**CITY OF VAUGHAN**

**EXTRACT FROM COUNCIL MEETING MINUTES OF JUNE 24, 2014**

**SITE DEVELOPMENT FILE DA.14.025  
CONDOR PROPERTIES LIMITED/MUZZO BROTHERS GROUP INC.  
WARD 4 – VICINITY OF LANGSTAFF ROAD AND NORTH RIVERMEDE ROAD**

**COMMITTEE OF THE WHOLE    JUNE 17, 2014**

## Building 'A' Elevations

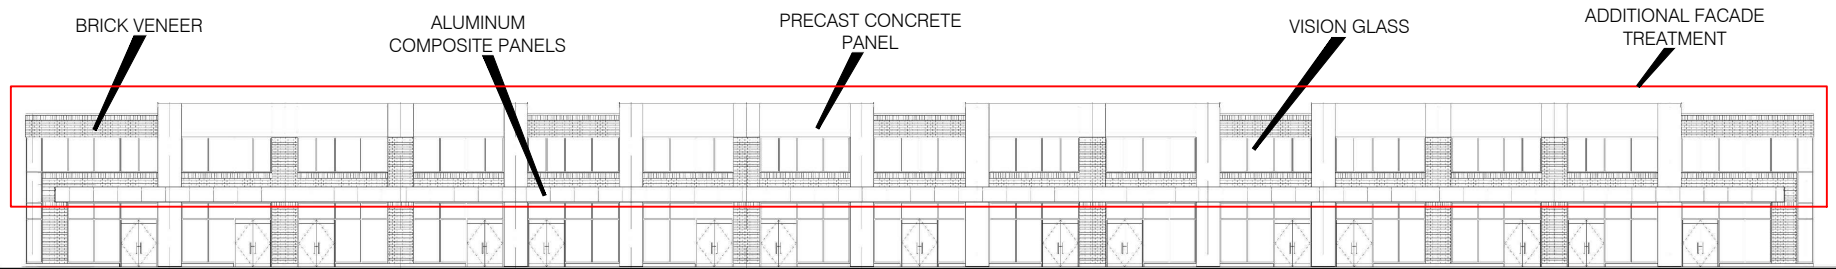
The proposed building elevations for the banquet hall, as shown on Attachment #5, consist of brick, stone and limestone veneer, stucco, aluminum composite panels and glazing. A dome shape metal roof will accentuate the main entrance of the banquet hall on the east elevation. As the proposed building is located adjacent to the existing Le Parc Park and is in proximity to the proposed multi-unit employment building, the Planning Department recommends that the west and south building elevations be enhanced to respond to these conditions, as highlighted on Attachment #5.

The proposed building elevations for the banquet hall, as shown on Attachment #5, consist of brick, stone and limestone veneer, stucco, aluminum composite panels and glazing. A dome shape metal roof will accentuate the main entrance of the banquet hall on the east elevation. As the proposed building is located adjacent to the existing Le Parc Park and is in proximity to the proposed multi-unit employment building, the Planning Department recommends that the west and south building elevations be enhanced to respond to these conditions, as highlighted on Attachment #5.

The Planning Department has discussed the recommended building elevation enhancements with the owner, who has agreed to work with the Department to enhance the elevations.

The Planning Department has discussed the recommended building elevation enhancements with the owner, who has agreed to work with the Department to enhance the elevations.
